SERVICE BULLETIN

M-1408C

2014-2015 TOURING SADDLEBAG MOUNT - SAFETY RECALL 0166

Reason for Revision

Figure 1. Saddlebag Stud Receptacles (shown inverted from installed position)

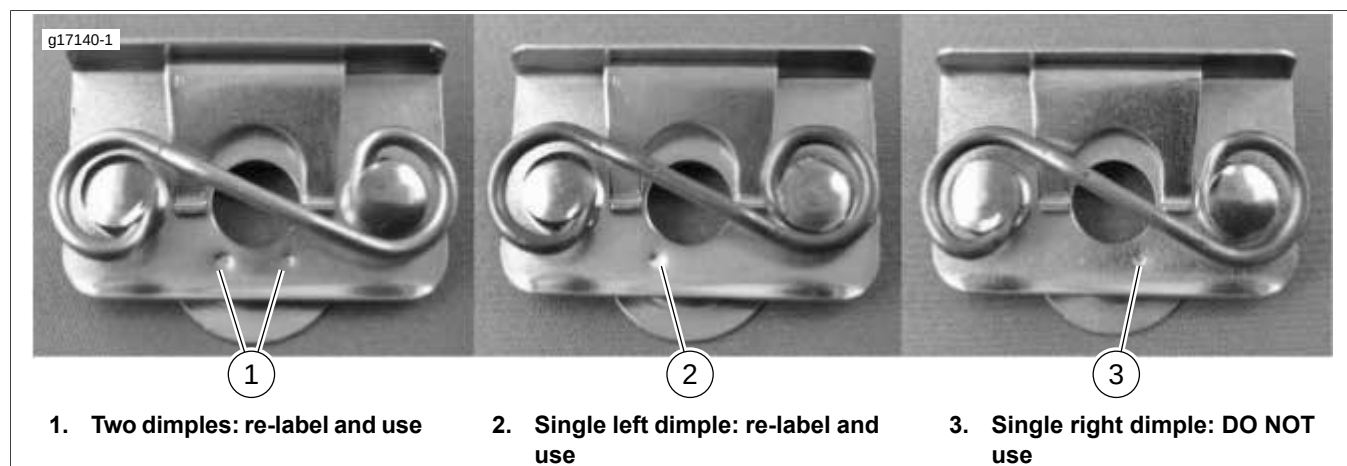
- Inspect all dealer inventory of kit 91500084.
 - If package has a date code of 07/14/15 or earlier, parts are good. Add an "A" after the part number.
 - See Figure 1. Inspect all later date code inventory of kit 91500084 as shown in the graphic.
 - Add an "A" to all kits that pass inspection.
- For kits that fail inspection, see 91500084 KIT RETURN PROCESS.

2. If recall kit package has date of 7/15/2015 or later than please sort per the attached photos, facing the spring side, clip opening down as shown.

Two Dots are good to use.
Add "A" to the Part No.
Kit is ready for use.

Left Dot is good to use.
Add "A" to the Part No.
Kit is ready for use.

Right Dot only **DO NOT USE.**

Figure 2. Saddlebag Stud Receptacles

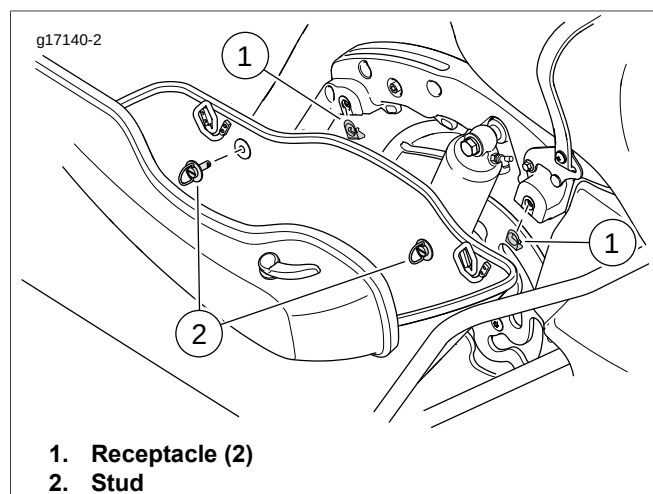
- Verify that the motorcycle is involved in this recall.
- See Figure 2. Remove saddlebags.
- Remove receptacles (1).
 - Insert a small screwdriver between receptacle clip and edge of saddlebag support.
 - Pry receptacle from saddlebag support.
- Install **new** receptacles supplied in kit.
- Install saddlebags using original studs (2) and washers.
- Confirm that stud has been rotated a **full 90 degrees** to ensure complete engagement.
